To: Mark Slovick, Project Manager
County of San Diego Planning and Development Services
5510 Overland Avenue, Suite 310
San Diego, CA 92123
Mark.Slovick@sdcounty.ca.gov
(858) 495-5172

Subject: Revised DEIR Public Comments Regarding Fire Protection Plan, Evacuation Study, and DEIR Chapter 2.7 Hazards Lilac Hills Ranch General Plan Amendment and Specific Plan PDS2012-3800-12-001(GPA), PDS2012-3810-12-001 (SP).

Subject: DEIR Public Comment to the Proposed Accretive Lilac Hills Ranch General Plan Amendment and Specific Plan PDS2012-3800-12-001(GPA), PDS2012-3810-12-001 (SP), Fire Protection Plan, Evacuation Study, and DEIR Chapter 2.7 Hazards

Figure 1 – Westerly and Easterly Evacuation Routes

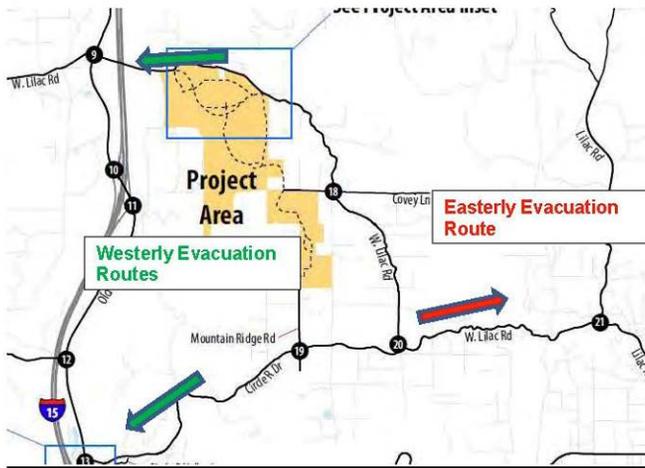
Evacuation Plan - The Evacuation Plan does not address the most fundamental evacuation issue of the Proposed LHR Project – the limited number of roads for automobile evacuation of the 5185 residents of the proposed LHR Project added to the existing area rural and semi-rural population.

The LHR Project has but two Public Roads that provide evacuation routes to the West: West Lilac Road to the north and Circle R Road to the South. Both are two lane rural Circulation Element 2.2 E roads for which **Accretive plans no upgrade**. Accretive is brazenly requesting exception to future County upgrade plans for portions of West Lilac Road to be **downgraded** from 2.2 C to 2.2 E capacity.

The LHR Project has but a single evacuation route to the East. That is the easterly section of West Lilac Road that connects to Lilac Road. It is a Circulation Element 2.2 E two lane rural road. The current as built configuration of this road does not meet current 2.2 E road design standards for certain design features, such as paved shoulder width, sight distance, design speed, curve radii, etc. There are no plans to upgrade this road. Accretive does not propose to pay for their direct development impact to this stretch of West Lilac Road.

Please refer to Figure 1 below that illustrates the proposed LHR Project Evacuation Routes:

With respect to the limited number of roadways and the number of future residents being added to the existing population, the project would provide additional emergency routes as shown in FEIR Figure 2.7-3. These evacuation routes will become available to the existing residents as the project constructs new roadways within the project and improves existing roadways in the area. Information related to these new roadways is included in the FEIR in subchapter 2.3.

<p>I51i-17 (cont.)</p> <p>The Evacuation Plan determined that the location of the project and the existing and planned roads provide adequate multi-directional primary and secondary emergency evacuation routes. (Evacuation Plan, page 8.) The primary evacuation routes are shown on Figure 2.7-3 of the Evacuation Plan, consisting of Main Street, Street F, Lilac Hills Ranch Road, Covey Lane, and Mountain Ridge Road. The project site also has a number of secondary emergency evacuation routes also shown on Figure 2.7-3. (FEIR, subchapter 2.7.2.3.) All proposed roads have been designed in accordance to the County Consolidated Fire Code and would exceed the driveway minimum horizontal radius, fall within the 20 percent maximum allowable grade and meet or exceed the minimum paved width requirements. Specifics of the proposed roadway designs compared to the Consolidated Fire Code are detailed in the Road Standard Comparison Matrix, Attachment P of the FPP.</p> <p>With respect to concerns regarding the exceptions being requested for the roadway improvements, these exceptions were included as part of the project's circulation design and considered as a part of the analysis for each subject area discussion within the FEIR. The exceptions could be granted by the County where capacity and safety are not unduly affected. (FEIR, subchapter 2.3.2.3.)</p> <p>With respect to the single evacuation route to the east and the roadway exceptions, the FEIR analyzed the issue of transportation hazards with respect to the road network designed for the project, and determined that impacts associated with transportation hazards would be less than significant. The overall road network design for the project would provide adequate ingress and egress for residents as well as emergency access and conform to General Plan Goal M-4. The roads within the project site were designed to accommodate emergency vehicles and allow residents to evacuate efficiently if necessary (General Plan Policy M-4.4) and the project would provide four connecting points to existing roads ensuring that both local and surrounding residents have alternate routes (Policy M-4.2). (FEIR, subchapter 2.3.3.3.)</p>

FIGURE 2
SIGHT DISTANCE ANALYSIS
CIRCLE R DRIVE AND MOUNTAIN RIDGE RD

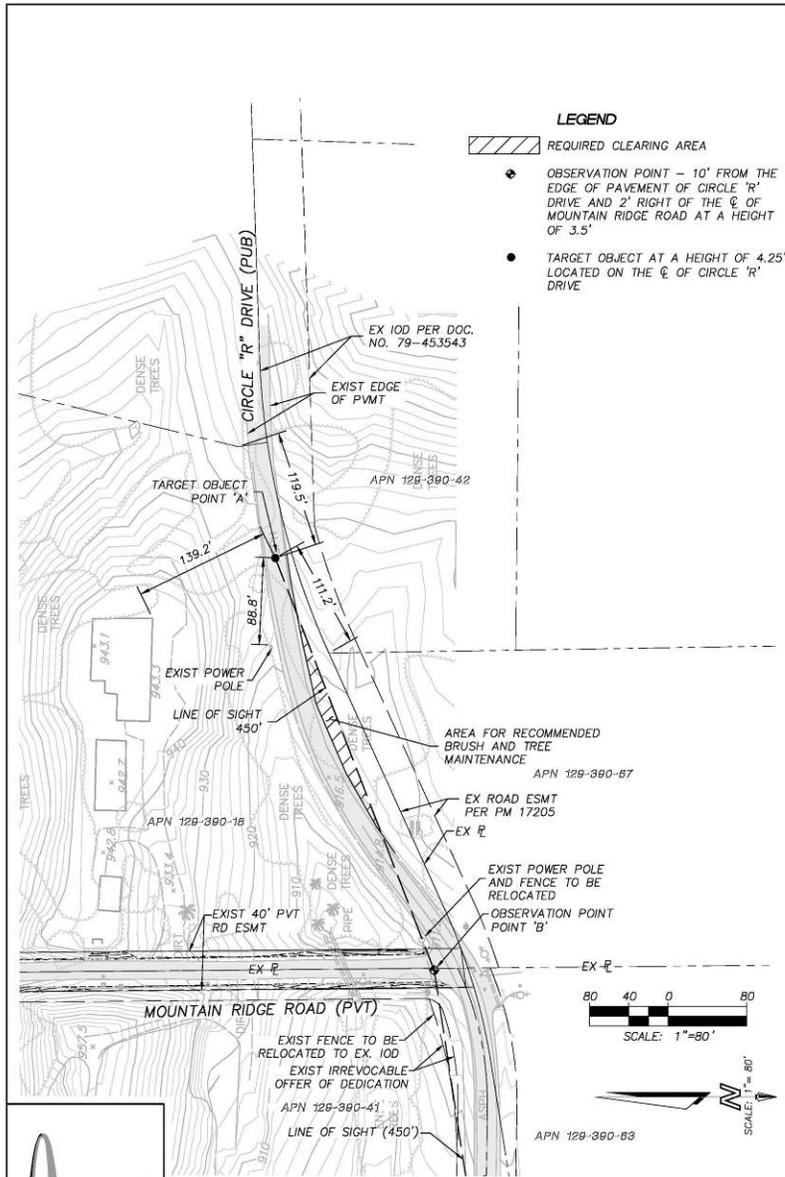
The Applicant has submitted the June 25, 2013 Sight Distance Analysis enclosed in Attachment E. This document states that the LHR Project as proposed is only able to achieve Sight Distance compliance by using a County Right – that of Prescriptive Easement Access for Brush Clearance – this right is not owned by the Applicant. How does the Applicant propose to legally provide Sight Distance compliance at this intersection?

151i-10 The comment states that the project does not have legal rights to provide the sight distance needed for Covey Lane and has not provided sufficient information regarding its compliance with County Consolidated Fire Code and County Private and Public Standards with respect to streets within the project to allow it to evacuate its residents safely. Please see also Global Response: Easements (Covey Lane and Mountain Ridge Roads) for a thorough discussion regarding the right to provide sight distance needed for Covey Lane. With respect to the ability to evacuate safely, please see response to comment 151i-17 below.
